MONUMENT
ACADEMY
HIGH SCHOOL

WALKER ROAD & JANE
LUNDEEN DRIVE
ROUNDBOUT
PH. 1 LANDSCAPE &
LIGHTING PLAN
SCALE : 1"=20'

RD1.2

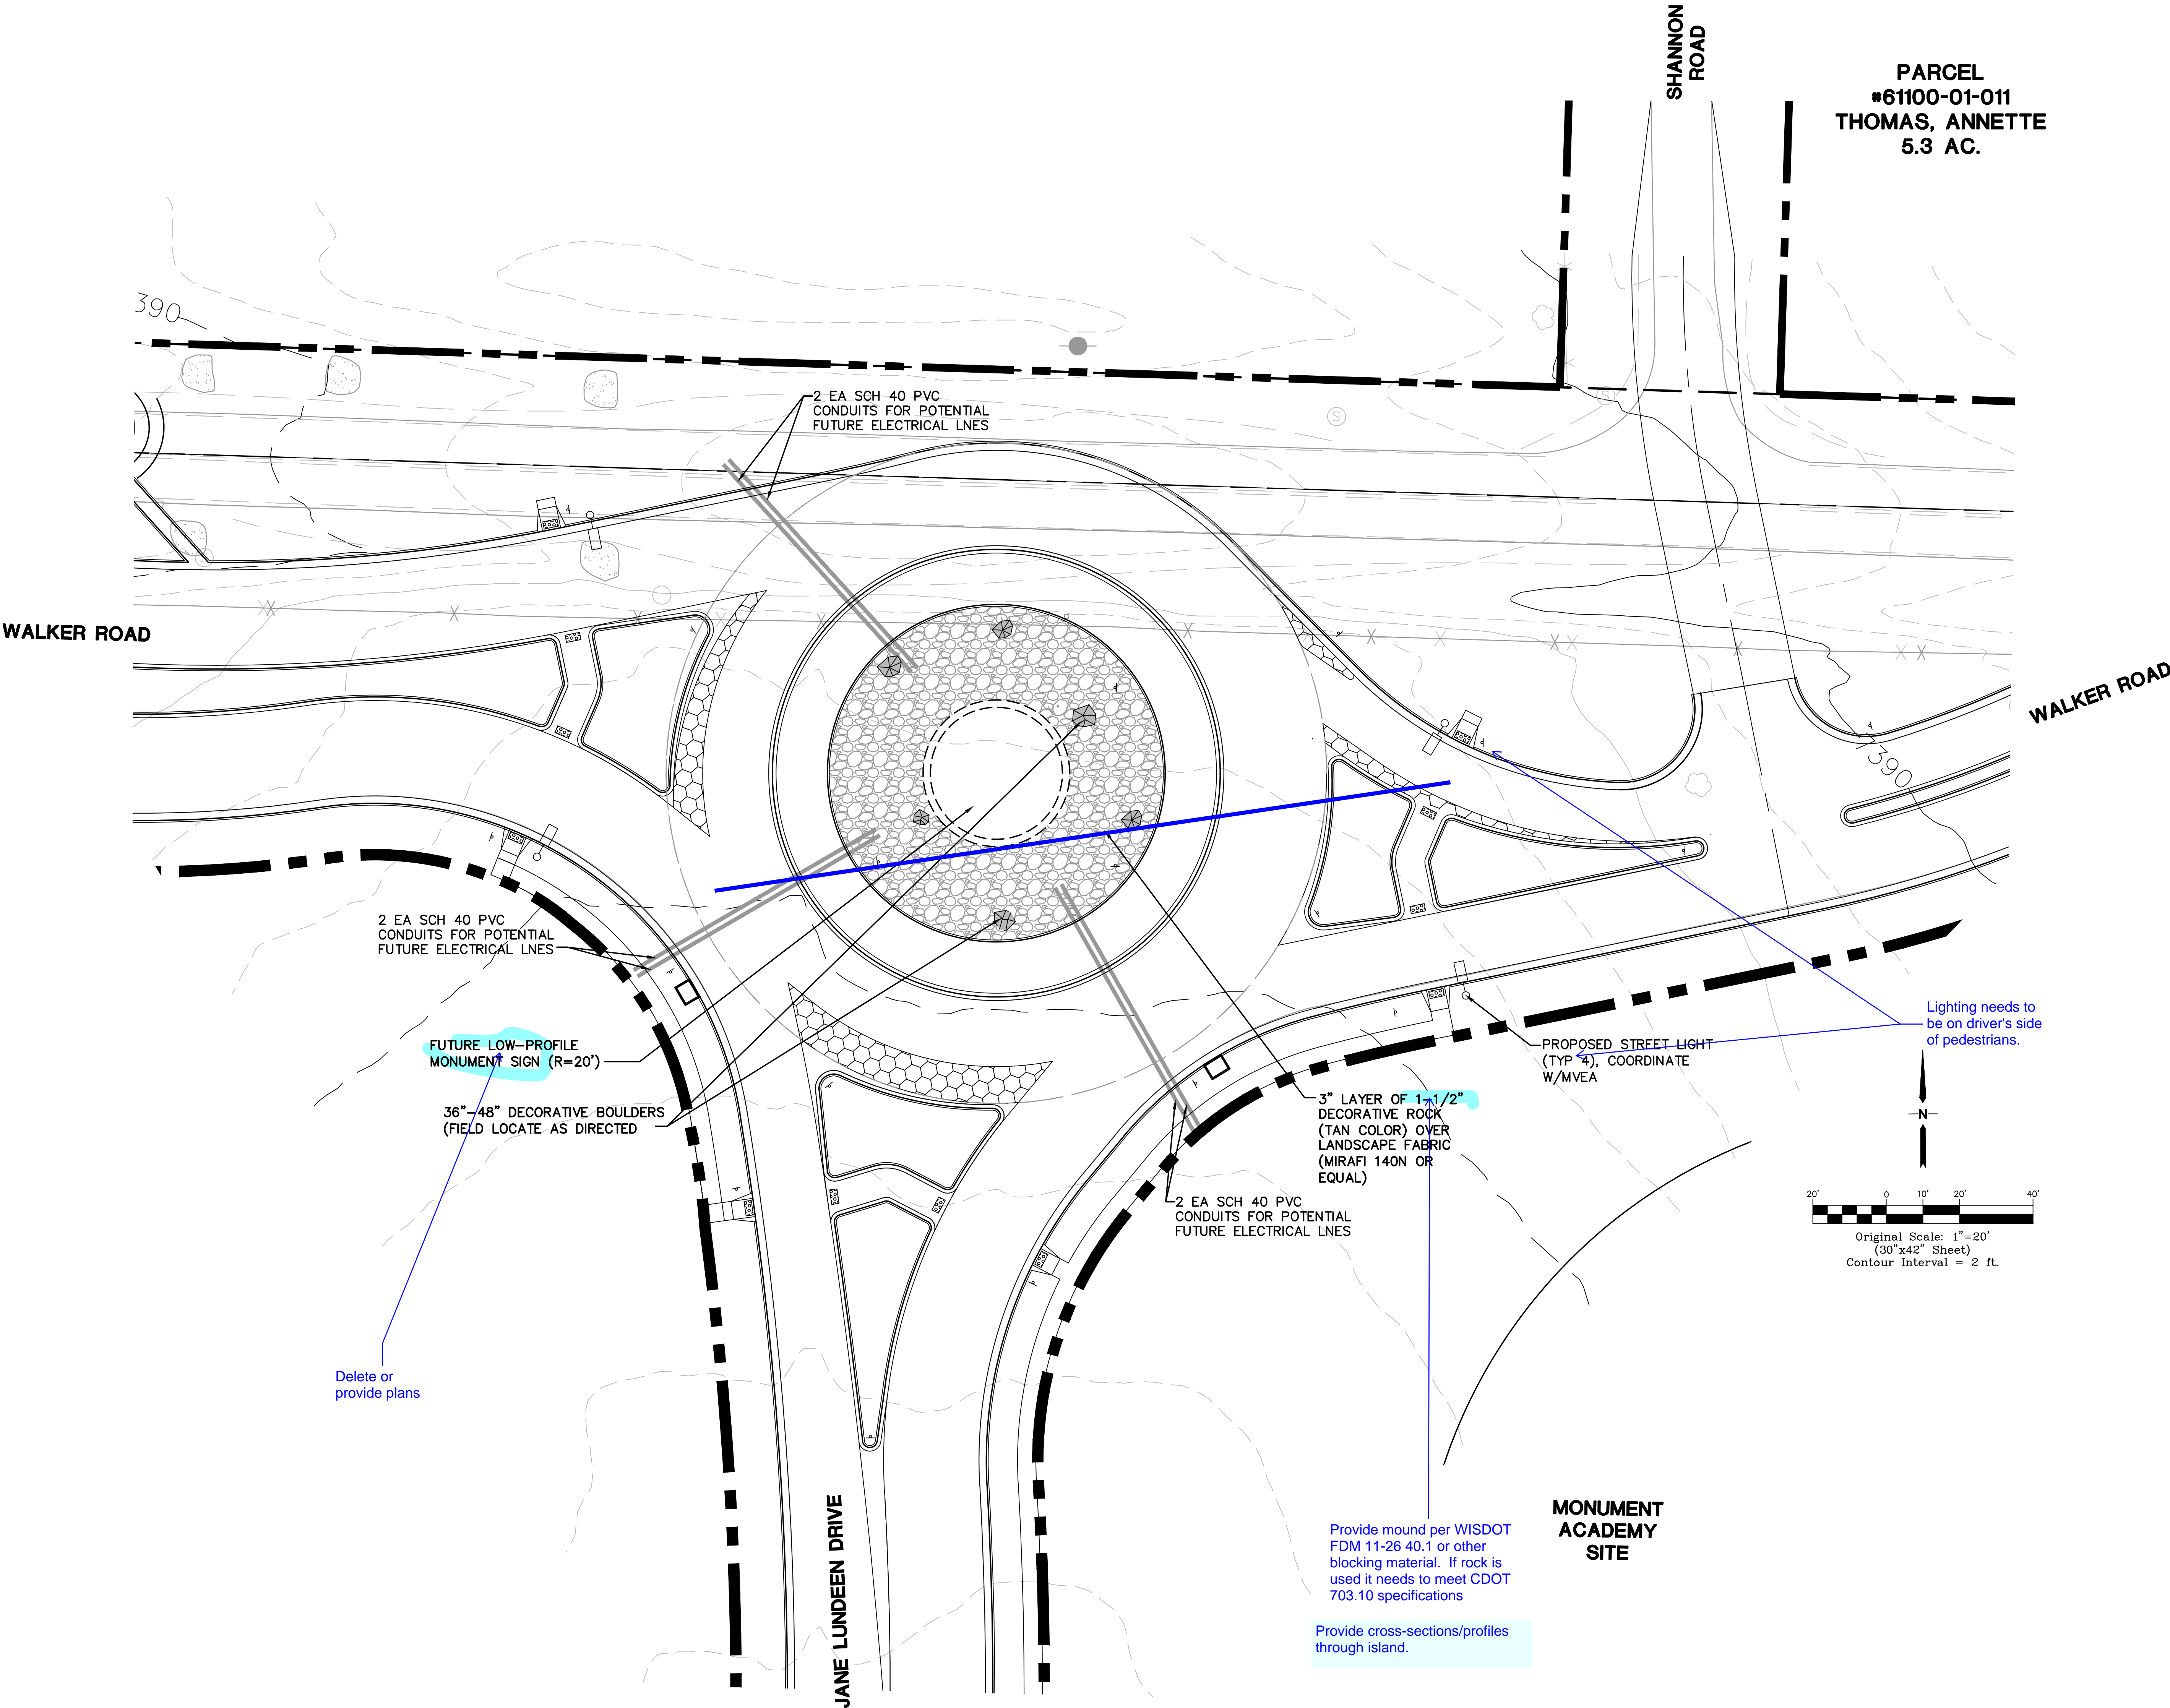
For lighting see:
<https://wisconsin.gov/dtsdManuals/traffic-ops/manuals-and-standards/teops/11-04.pdf>

Provide mound per WISDOT
FDM 11-26 40.1 or other
blocking material. If rock is
used it needs to meet CDOT
703.10 specifications

Provide cross-sections/profiles
through island.

Delete or
provide plans
